ADDRESSEES	: Owners and operators of vehicles mentioned under "Application" ABC Customer Care and Parts Source
VEHICLE TYPE	: CX45 MY2023/2025
CONFIGURATION GROUP	: 2.34 Traction motor – Cooling system
BULLETIN TYPE	: Field change program
DATE	: December 05th, 2025
SUBJECT	: To install additional supporting point for cooling pipes
CONDITIONS	: Refer to chapter "Warranty" further on in this bulletin.

This field change program bulletin is applicable to the following vehicles:

Figure 1: Additional cooling pipe supporting point (at rear of vehicle)

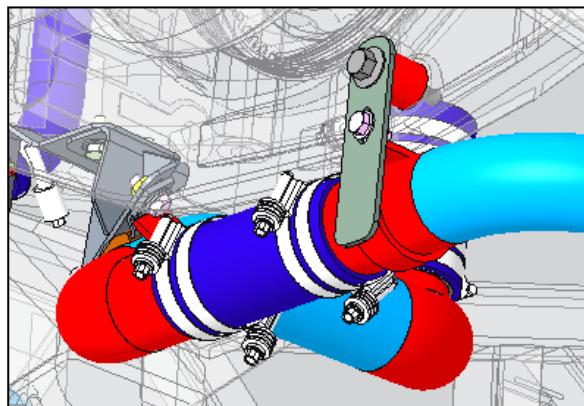
To address this issue, VDL Van Hool is conducting a field change program whereby the front and rear supporting points indicated in figure 2 must be checked for possible damage. In addition, an extra cooling pipe supporting point (figure 1) must be installed at the rear of the vehicle.
